Title - Sujet CCGS Griffon 2012 Refit - Alongside		
Solicitation No. - N° de l'invitation F2599-120160/A		Amendment No. - N° modif. 002
Client Reference No. - N° de référence du client F2599-120160		Date 2012-08-21
GETS Reference No. - N° de référence de SEAG PW-\$\$MD-018-23038		
File No. - N° de dossier 018md.F2599-120160	CCC No./N° CCC - FMS No./N° VME	
Solicitation Closes - L'invitation prend fin at - à 02:00 PM on - le 2012-08-23		Time Zone Fuseau horaire Eastern Daylight Saving Time EDT
F.O.B. - F.A.B.		
Plant-Usine: <input type="checkbox"/> Destination: <input type="checkbox"/> Other-Autre: <input type="checkbox"/>		
Address Enquiries to: - Adresser toutes questions à: Vandal, Paul		Buyer Id - Id de l'acheteur 018md
Telephone No. - N° de téléphone (819) 956-0645 ()		FAX No. - N° de FAX (819) 956-0897
Destination - of Goods, Services, and Construction: Destination - des biens, services et construction:

CCGS GRIFFON
PWGSC FILE No. F2599-120160/A
BIDDER'S CONFERENCE
RECORD OF DISCUSSION

CCGS GRIFFON
PWGSC FILE No. F2599-120160/A
BIDDER'S CONFERENCE #2
RECORD OF DISCUSSION

Checked SELIM ULLAH			NEW RADAR WIRE WAY INSTALLATION		
Scale	1/2" = 1'-0"	Sht.	Project	CCGS GRIFFON	Naval Architect
Date	MAY 2012	2/2	Client	CANADIAN COAST GUARDS Sarnia, Ontario	 KAM Technology 3 Keholme Cresc. Thorold ON L2V 4C1 Tel/Fax: (905) 227 7388
Dwg.no.	EN12527-01	Rev. 1

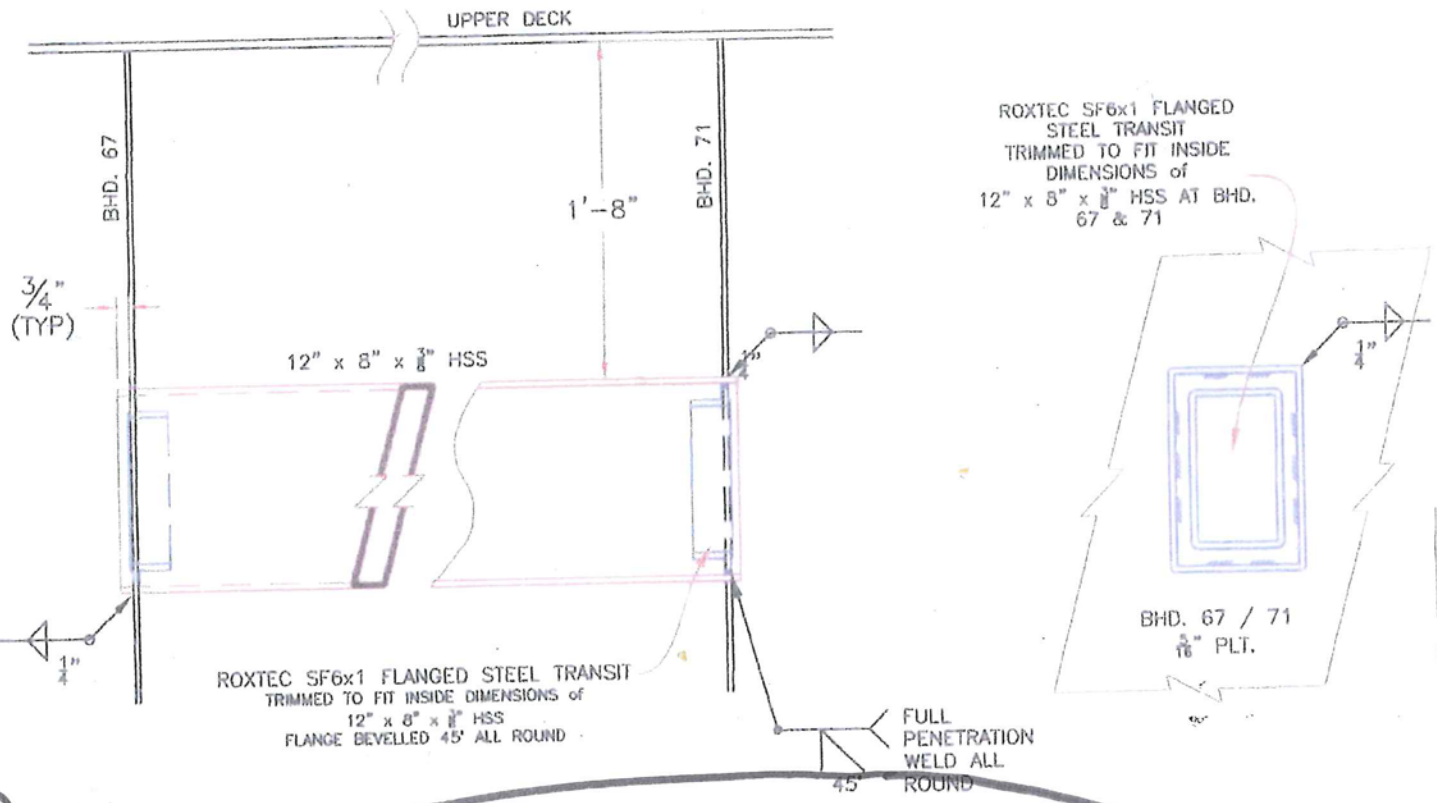
Clarification: Drawing for work now have TCMS comments (See attached TCMS comments)

Transits (GFE) to be TCMS approved. Testing to be I.A.W. local TCMS Inspector.
